**HISTORIC PRESERVATION BOARD  
DESIGN REVIEW COMMITTEE  
STAFF REPORT  
April 23, 2026**

<b>Project #</b>	<b>HPB26-046</b>
<b>Project Type</b>	<b>New Construction of a Single-Family House</b>
<b>Property Address; Historic Name</b>	<b>309 Ariana Street N/A</b>
<b>Historic District; FMSF#</b>	<b>Dixieland Historic District; N/A</b>
<b>Owner/Applicant</b>	<b>Line Flooring &amp; Remodeling LLC / Osbel Diaz</b>
<b>Zoning; Context District; Future Land Use; SPI</b>	<b>RA-4; Urban Neighborhood; Residential Medium; Dixieland SPI</b>
<b>Existing Use</b>	<b>Residential</b>
<b>Adjacent Properties</b>	<b>Residential</b>
<b>Previous Approvals</b>	<b>New single-family house, 2/23/2017 (HPB17-019); New single-family house, 11/21/2019 (HPB19-214)</b>

# NEW RESIDENCE AT 309 ARIANA STREET, LAKELAND, FL 33803

SITE PLAN  
SCALE: 1"=20'-0"

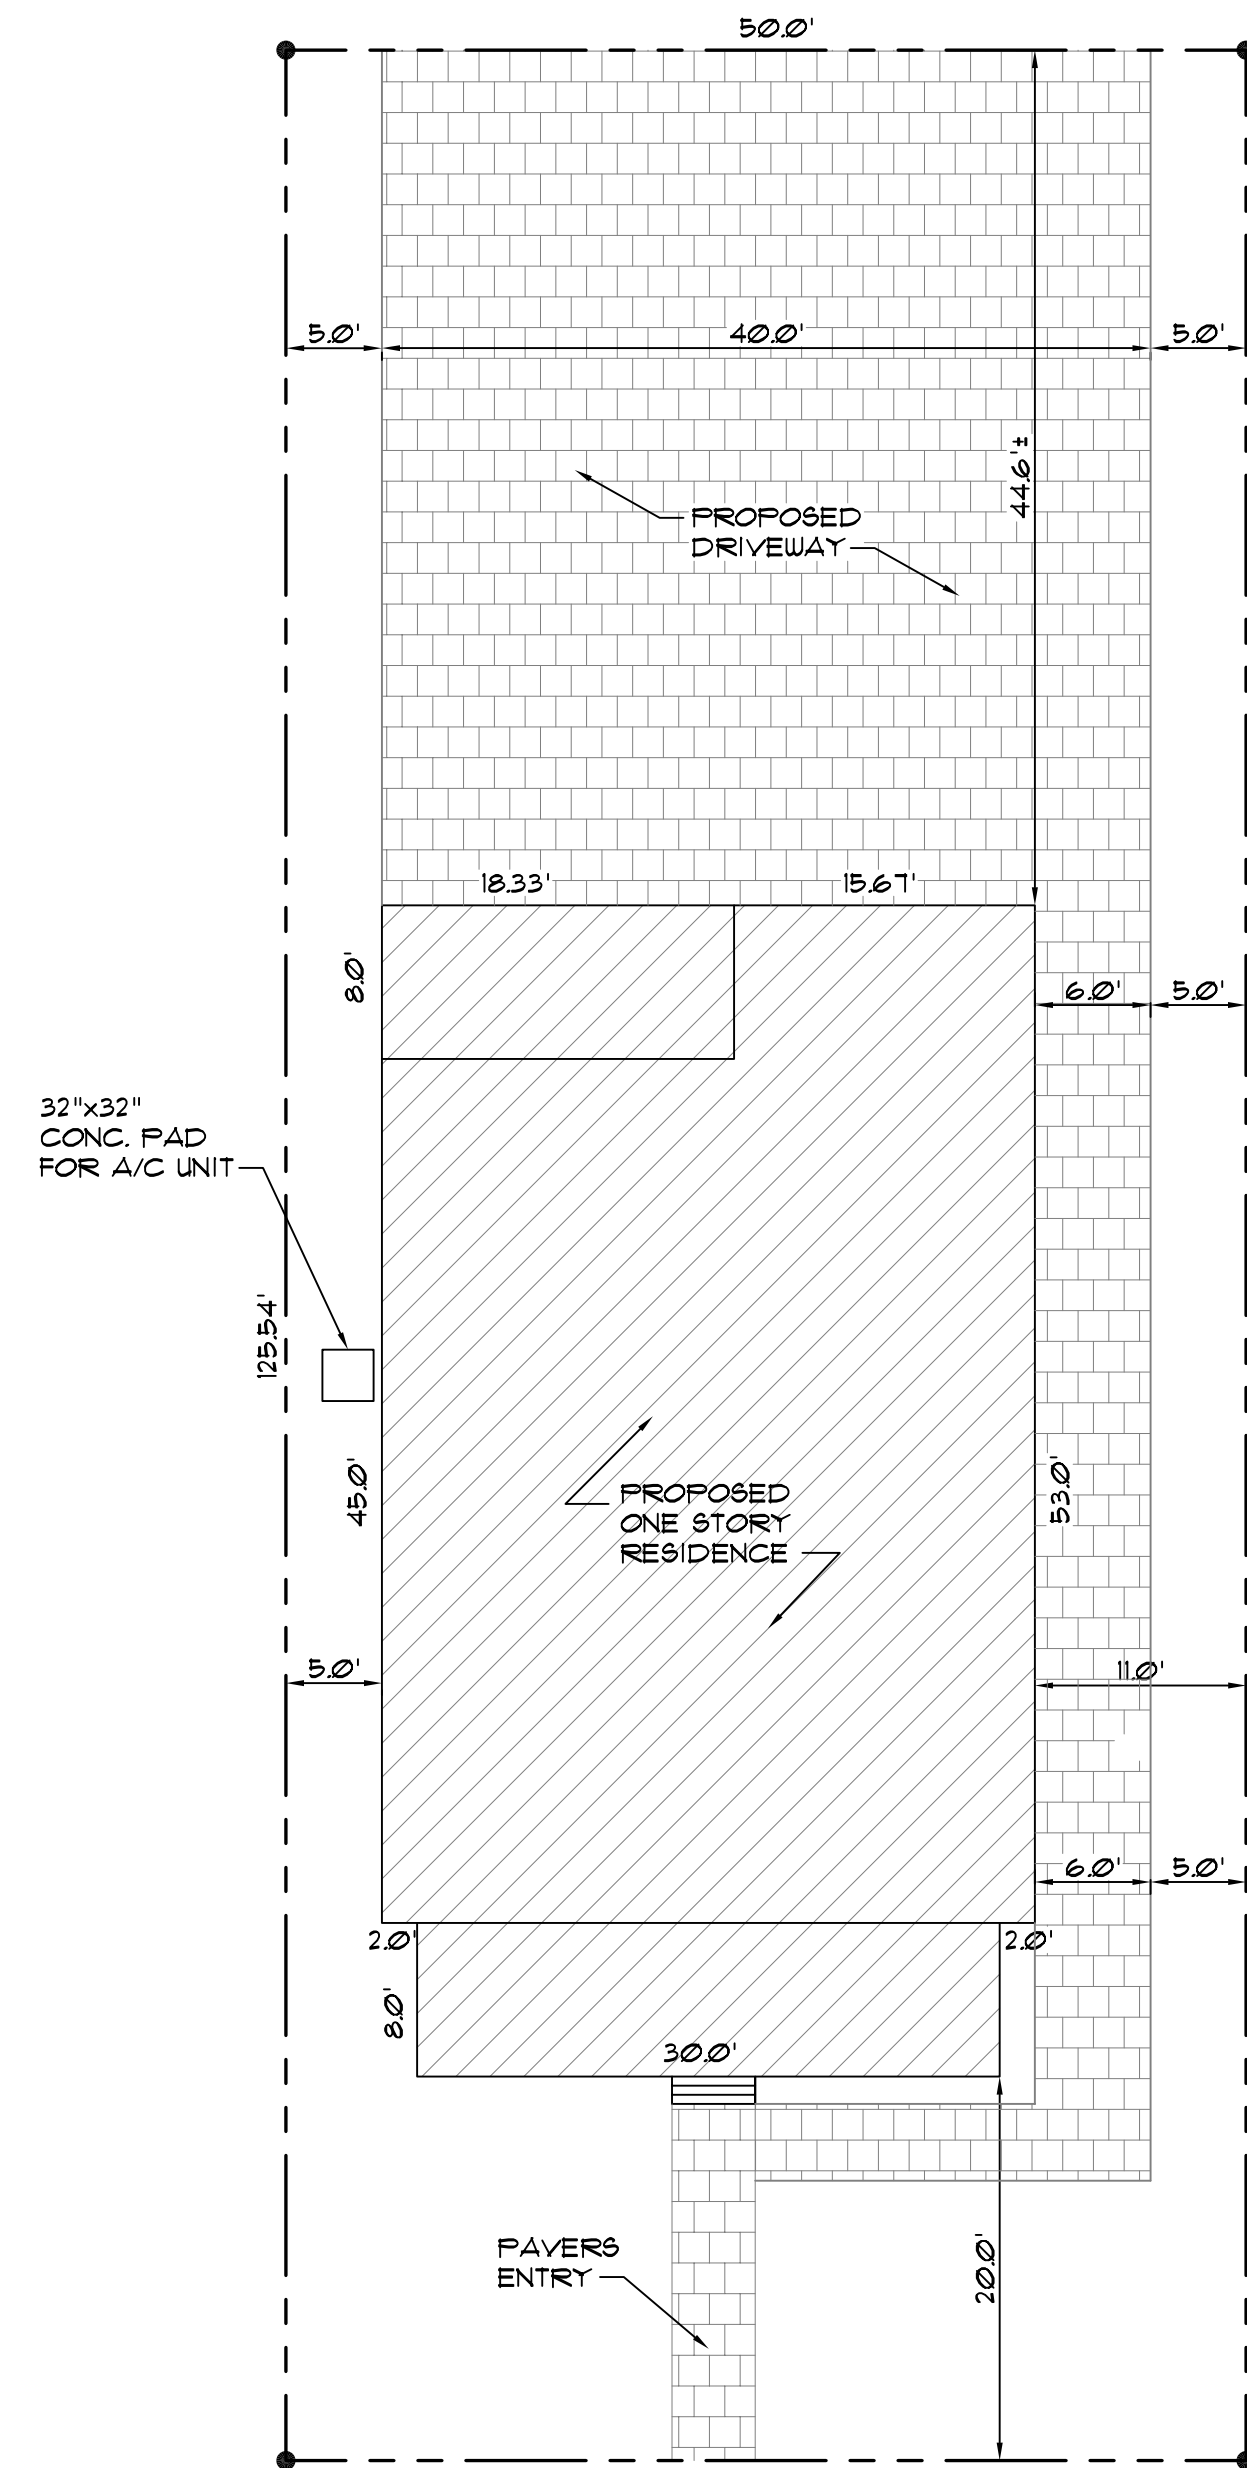
The site plan proposed for the proposed new construction shows orientation of the home’s front façade towards Ariana Street. The proposed building setbacks for the house meet the Land Development Code’s

Urban Neighborhood Standards; however, the porch depth at six (6) feet must be increased to eight (8) feet to meet the Urban Neighborhood Standards.

Finally, the proposed placement of the house on the lot is consistent with the Design Guidelines and Urban Neighborhood Standards in terms of orientation and building setbacks. As mentioned previously, to comply with the Urban Form Standards, the depth of the front porch must be increased to eight (8) feet. The front yard building setback at 20 feet is compatible with the houses adjacent to the subject property; 305 Ariana Street to the east of the subject property is setback approximately twenty-one (21) feet from the property line and 315 Ariana Street to the west of the subject property is setback approximately eighteen (18) feet from the property line. Staff finds the 40-foot wide parking area at the rear of the house to be out of scale and dimension with historical driveways and parking pads and recommends reducing the width to twenty (20) feet and placed in line with the walkway on the east side of the house.

1. Windows must be recessed to provide a shadow line and not installed flush to the exterior wall surface. Windows also must include historically appropriate trim, including header and sill.
2. Paired windows must have a mullion in between window units of at least 4 inches wide.
3. Submittal of an exterior paint palette.
4. Increase depth of the front porch to eight (8) feet.
5. Reduce width of the driveway area to twenty (20) feet.
